**FINAL MITIGATION PLAN**  
**MIDDENDORF SPRINGS MITIGATION SITE**  
**ANSON COUNTY, NORTH CAROLINA**

DMS Project No.100151  
DWR Project No. 2020-0775v1  
NCDEQ Contract No. 8012-01  
USACE Action ID No. SAW-2021-01973

Re: NCIRT Review and USACE Approval of the NCDMS Middendorf Springs Mitigation Site /  
Anson County

Re: DMS Project ID # 100151 / Middendorf Springs Stream and Wetland Mitigation Site Mitigation Plan  
IRT Comments

**Figure 3 Landowner Map**  
Middendorf Springs Mitigation Project  
Anson County, NC

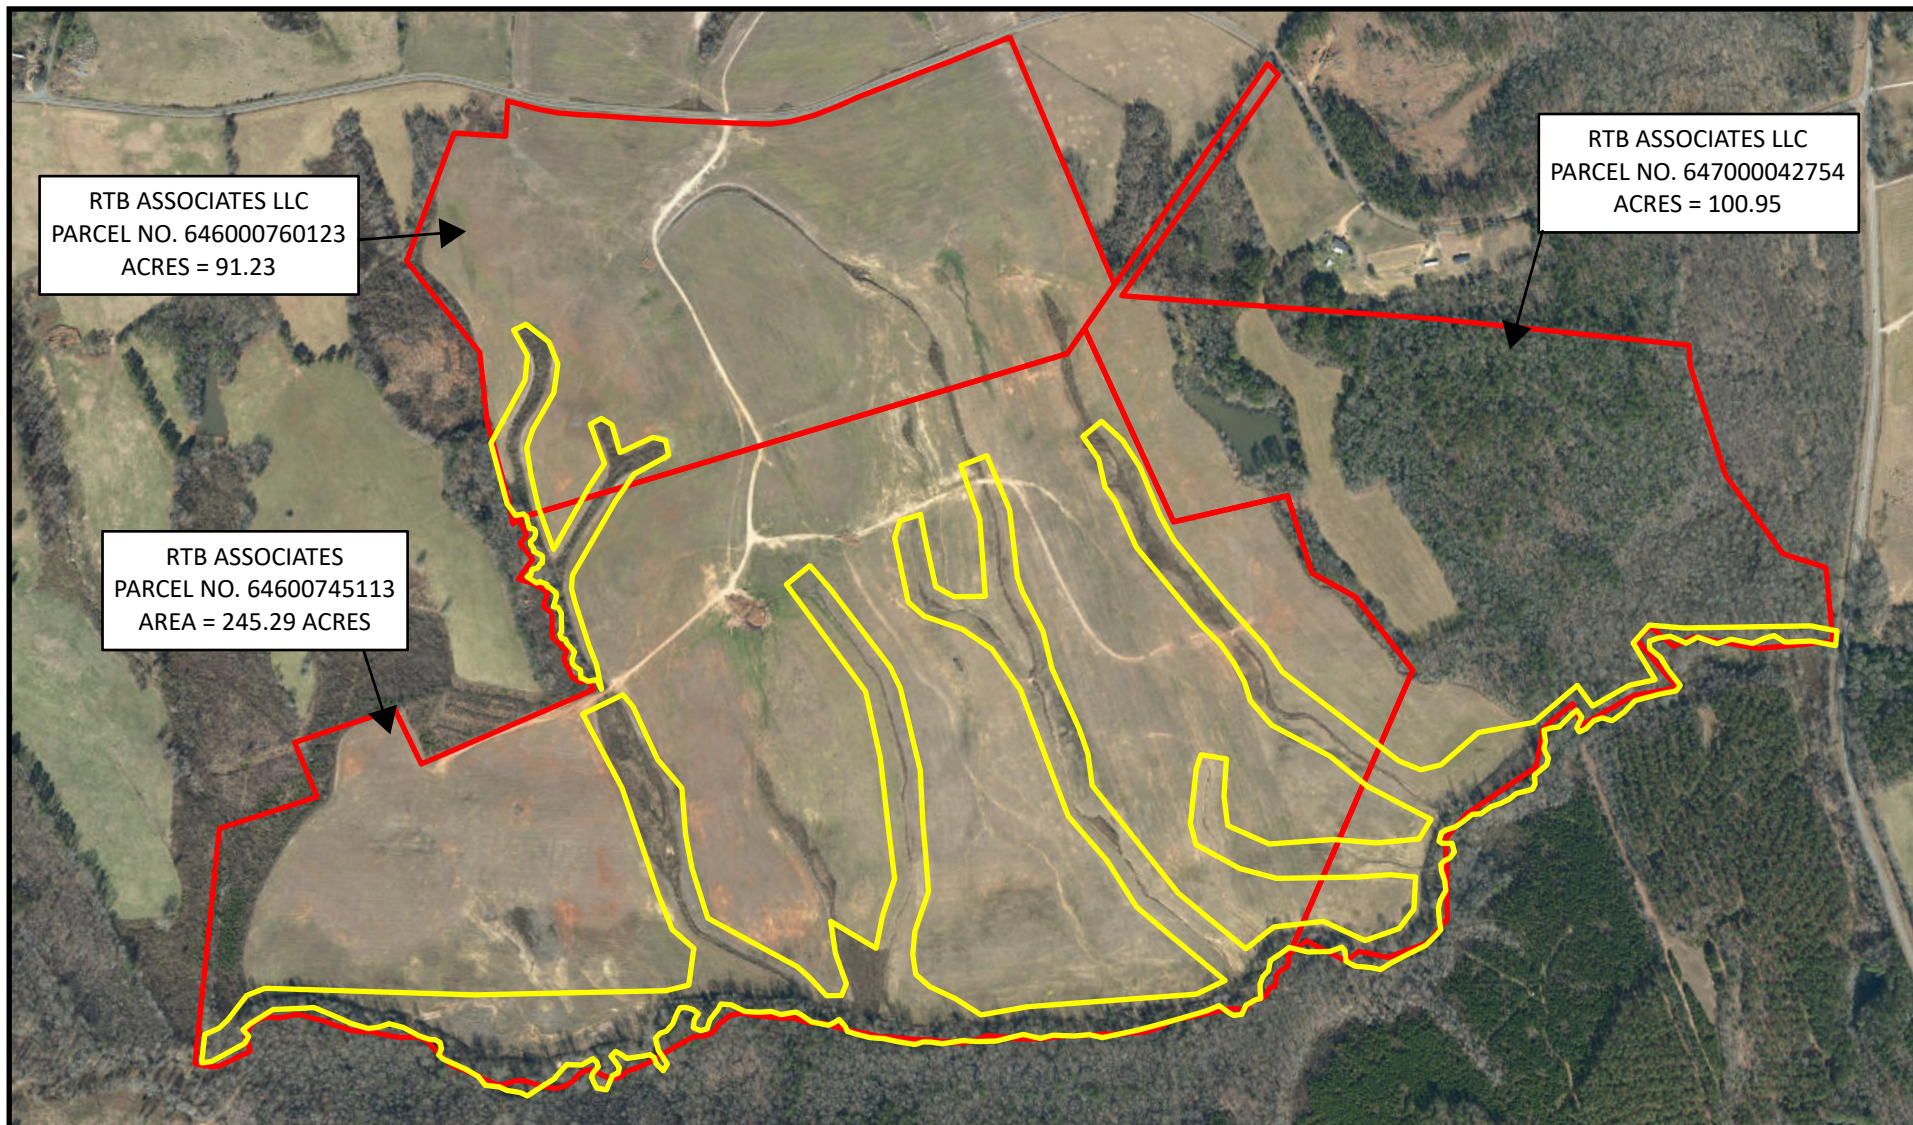
**Figure 3 Landowner Map:** *The easement appears to be outside the extent of the parent tracts. Are the boundaries for the parent tracts the stream centerline?*

**Figure 4 Land Use Map**  
Middendorf Springs Mitigation Project  
Anson County, NC  
NCDMS Project #:100151

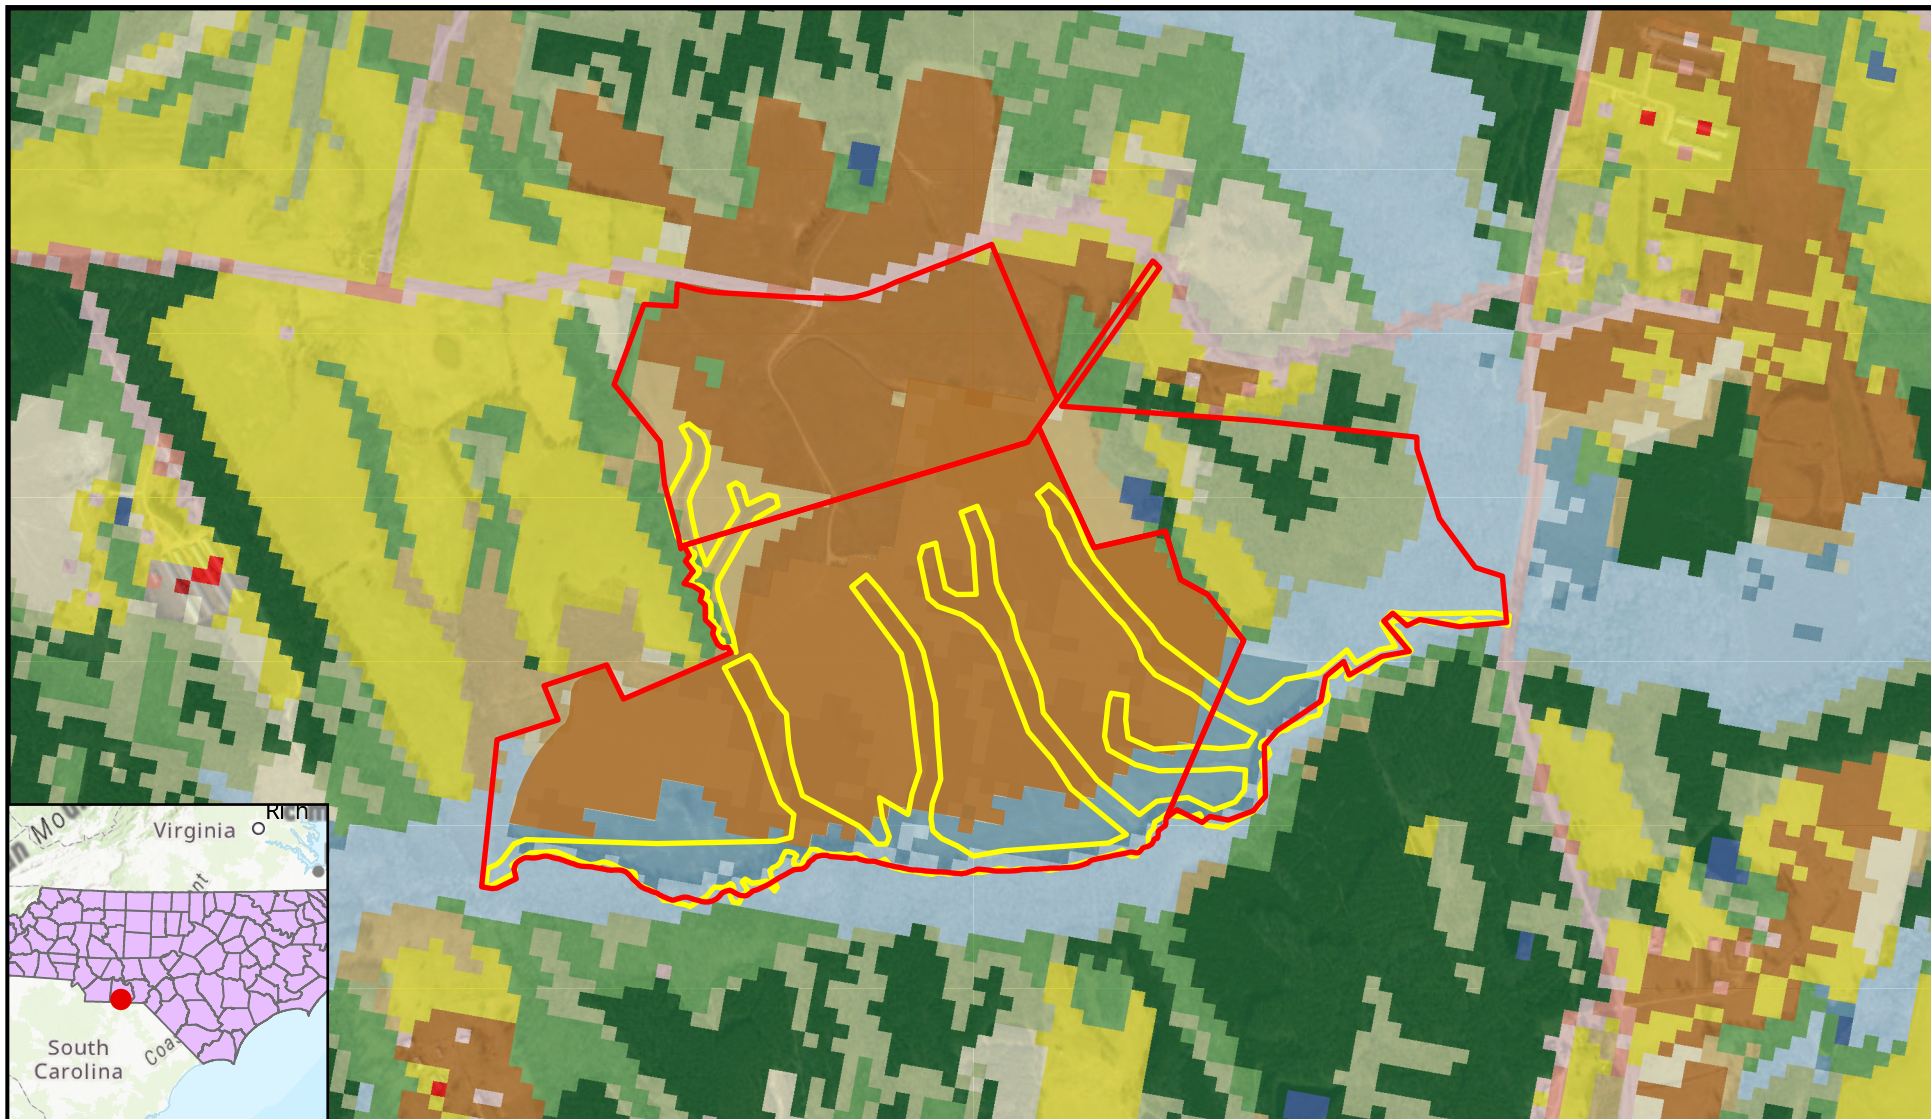
**Figure 4 Land Use/Land Cover Map:** *Please include the easement boundary in this figure.*

**Figure 7 Drainage Area Map**  
Middendorf Springs Mitigation Project  
Anson County, NC

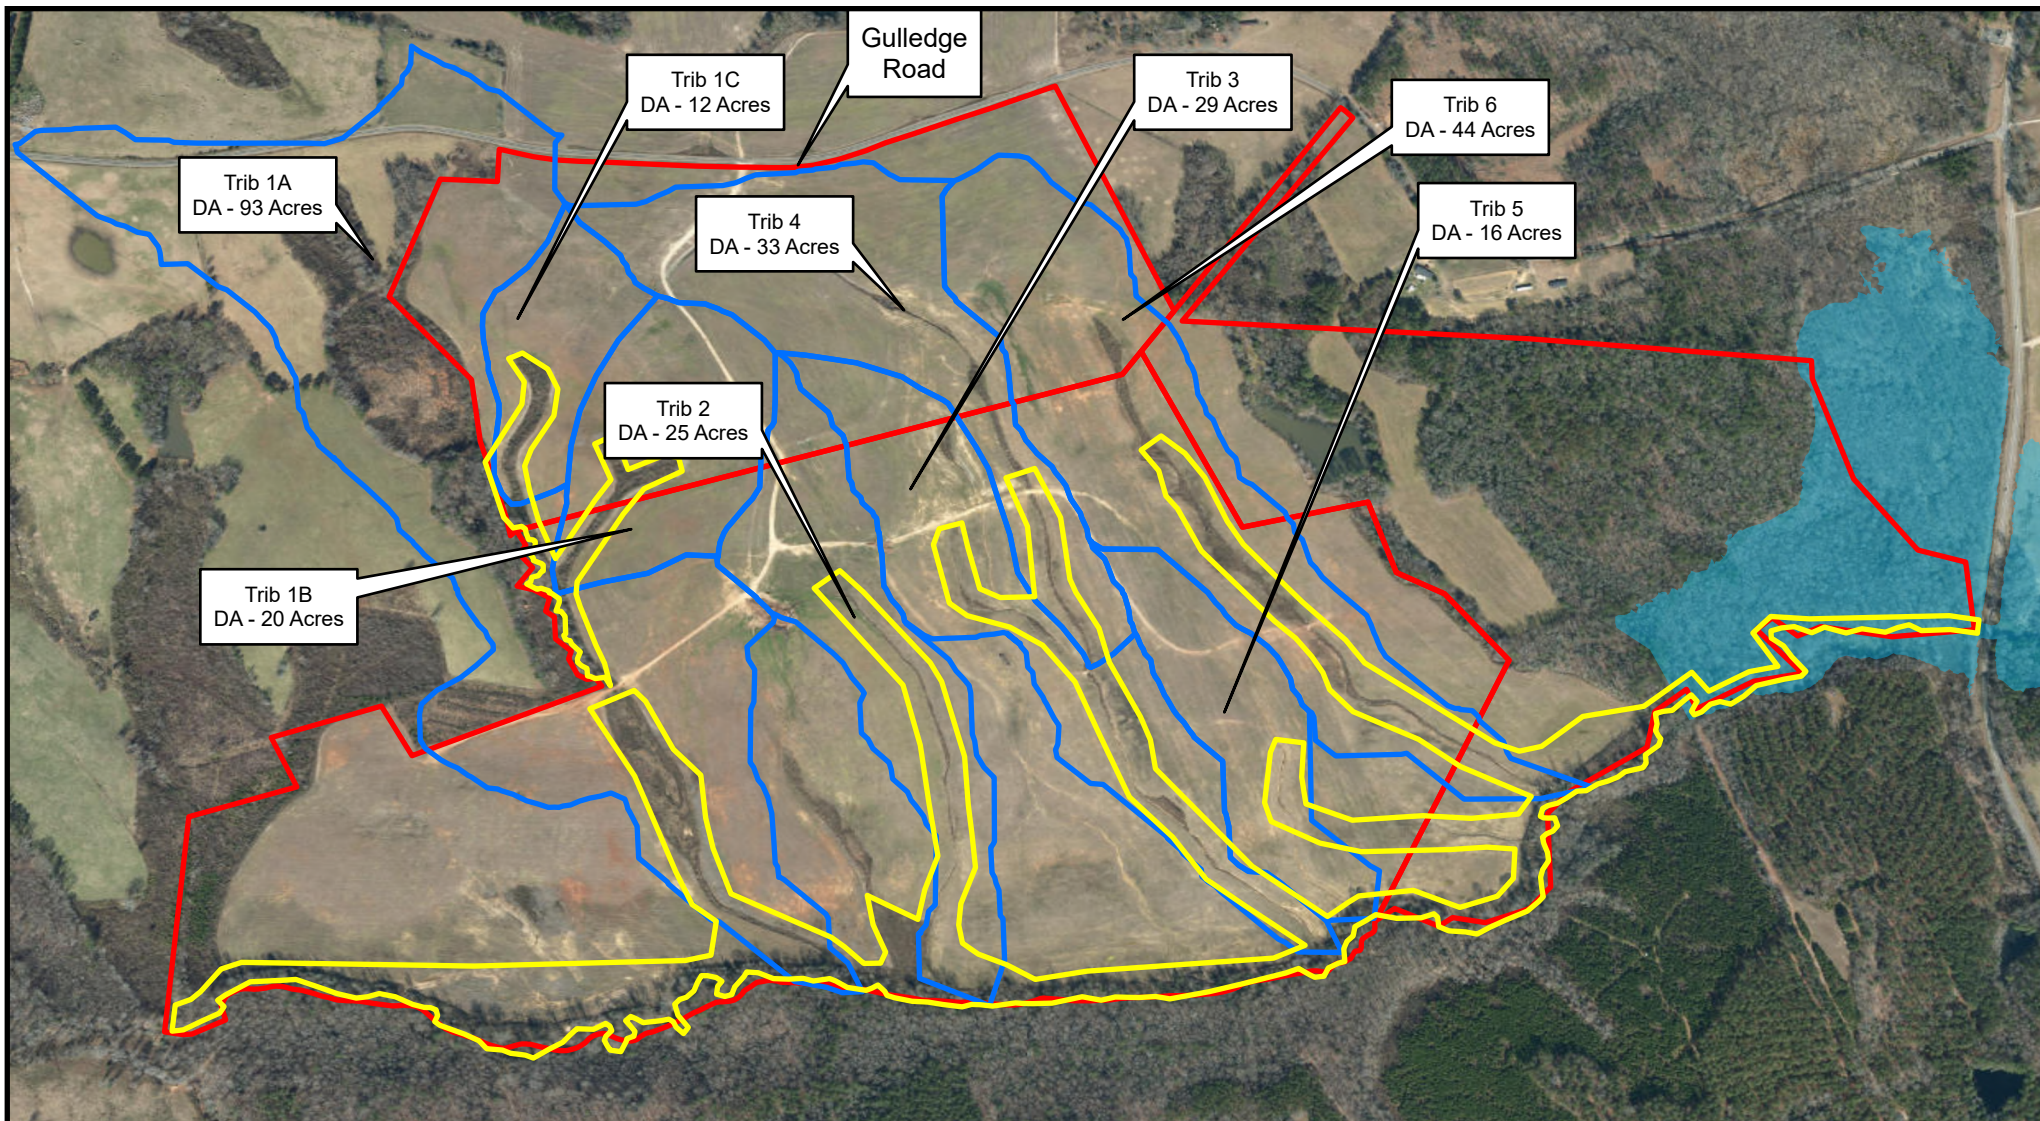
- 9. Figure 7. It would have helpful if the drainage area acreage would have been listed on the map.**

16. **Figure 7: Please show drainage area acreages on the map.**

Figure 7 has been revised to include the drainage area acreage.

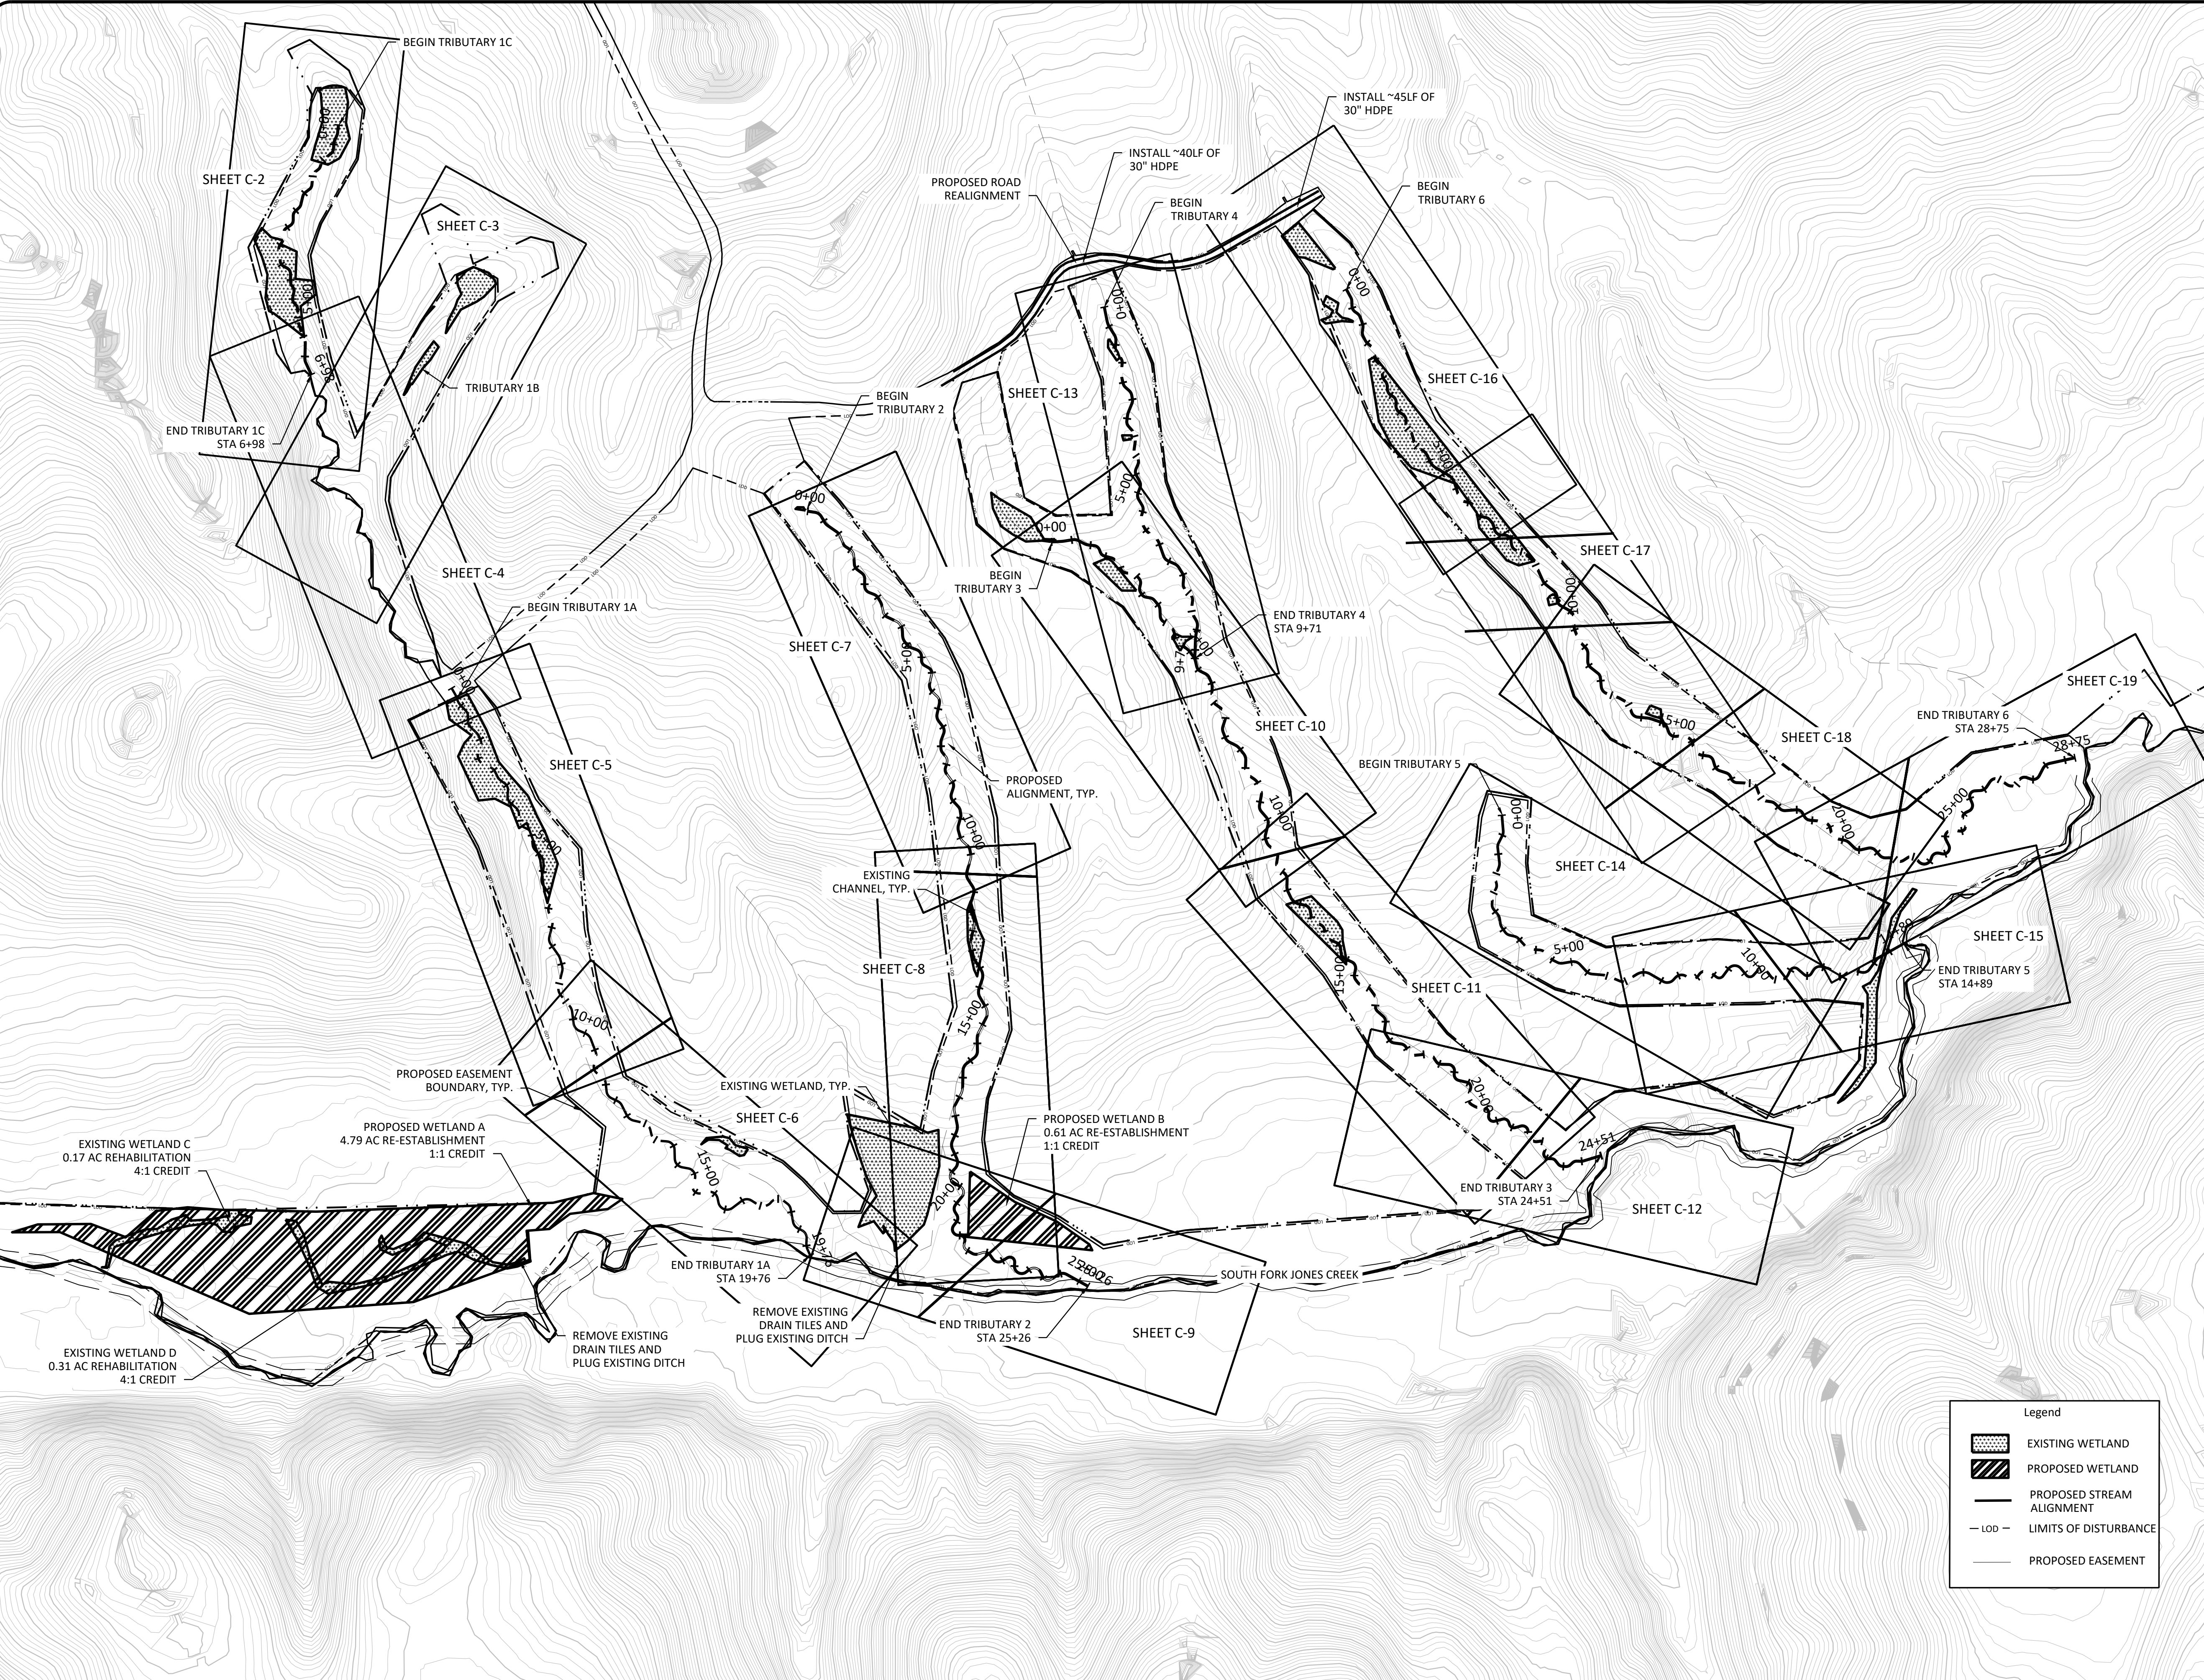
***Sheet C-1:*** Recommend indexing overview map with sheet number for individual pages.
